DEPARTMENT OF ENVIRONMENTAL MANAGEMENT
 OFFICE OF WATER RESOURCES
 FRESHWATER WETLANDS PROGRAM
 APPROVED WITH CONDITIONS
 AS SPECIFIED IN THE LETTER OF APPROVAL
 DATED JUL 31 2008 FILE # 08-091
 NO CHANGES ALLOWED WITHOUT PRIOR APPROVAL.
 APPROVED PLANS MUST BE AT CONSTRUCTION SITE.

PROPOSED OWTS NEW CONSTRUCTION
 PREPARED FOR
STEVEN & KELLY MAURICIO
 MAP 4-7 BLOCK 142 CARDS 2 & 2E
 R.O.W. OFF CRANDALL ROAD
 TIVERTON, RHODE ISLAND

- PROPOSED PLANTINGS - Revised per DEM
 3'-4' TALL, 5'-ON-CENTER
 PLANTINGS TO BE AN EQUAL DISTRIBUTION OF THE FOLLOWING:
 - (NORTHERN WHITE CEDAR - THUJA OCCIDENTALIS)
 - (NORTHERN BAYBERRY - MYRICA PENNSYLVANICA)
 - (INKBERRY - ILEX GLABRA)
 - (BEACH ROSE - ROSA RUGOSA)
 (SEE DETAIL)

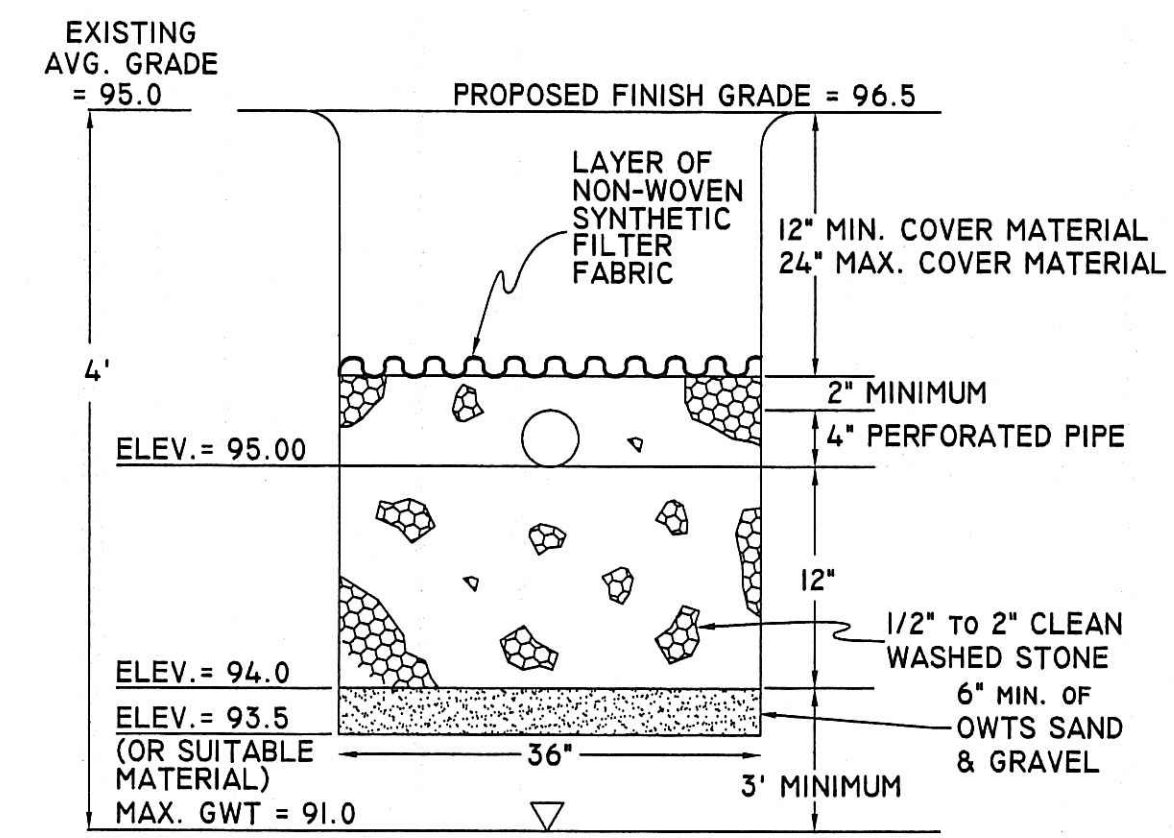
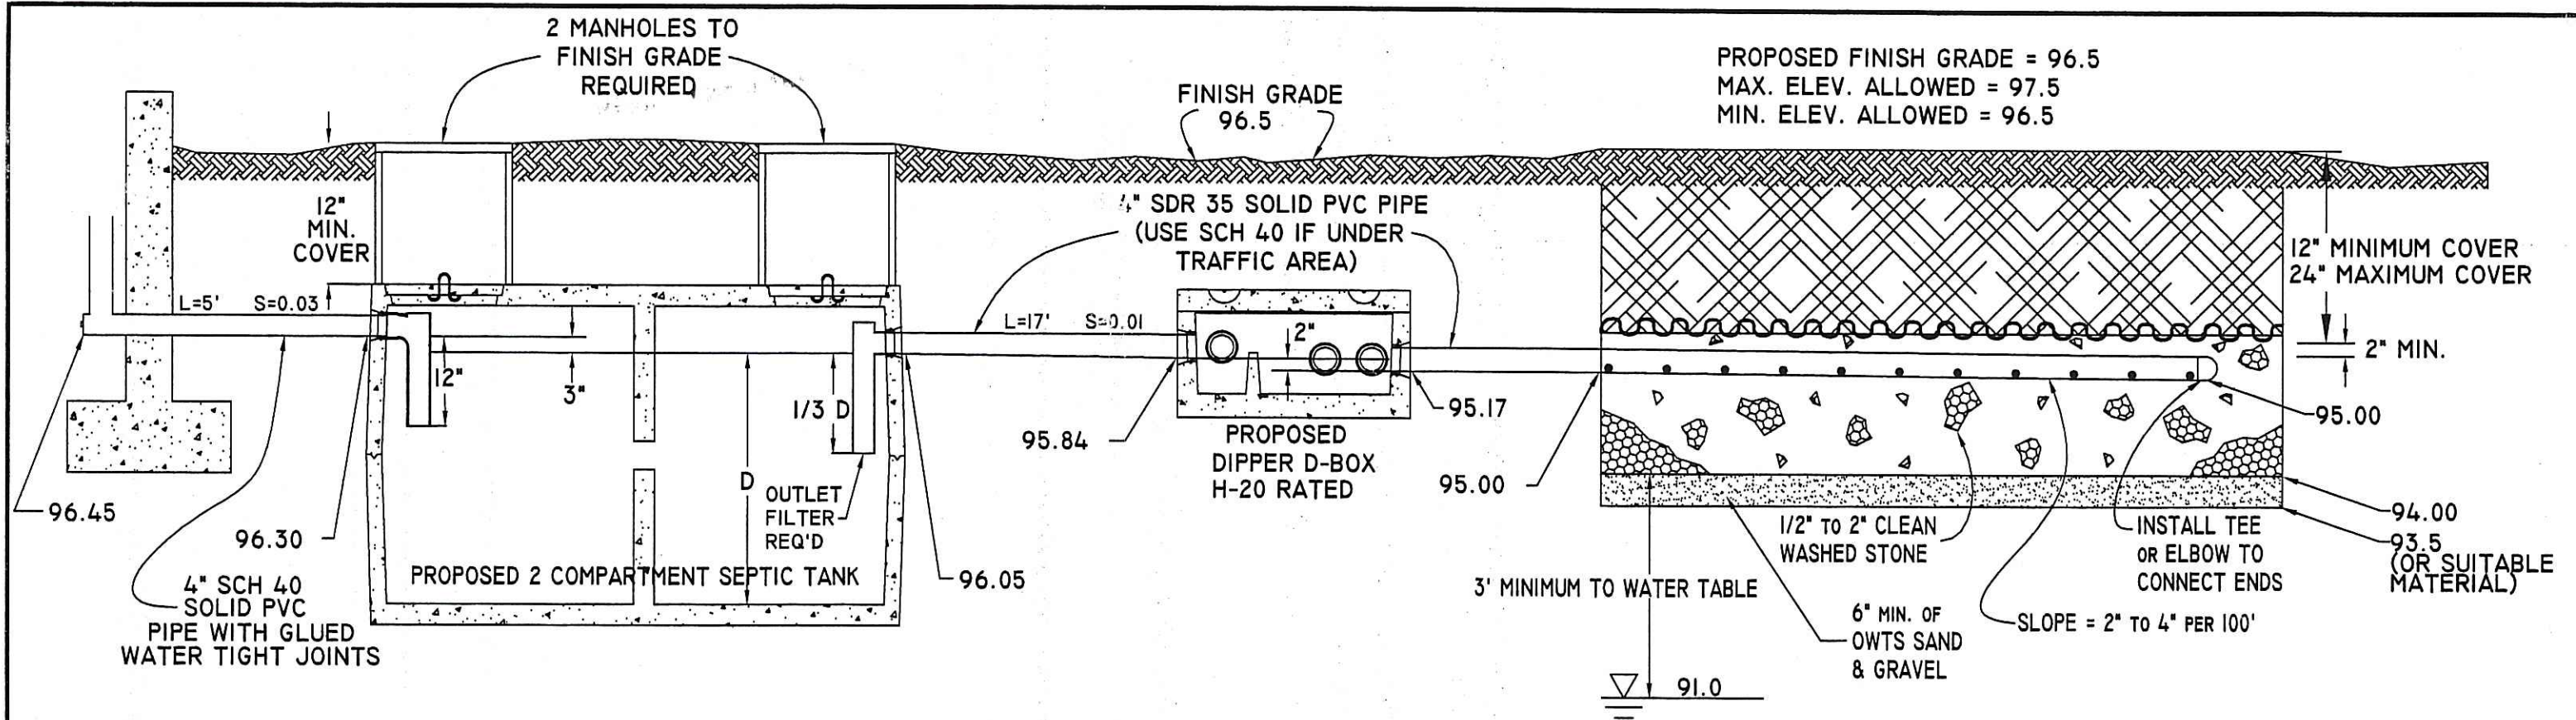
Plantings shall consist of a double row of evergreens planted along the limit of disturbance. The back row shall consist of white spruce (Picea alba) or (Picea glauca) planted eight feet on center and five feet high after planting. The front row (closest to the proposed dwelling) shall consist of Northern white cedar (Thuja occidentalis), planted six feet on center and three to four feet high after planting. The proposed shrubs may be deleted from the planting schedule.
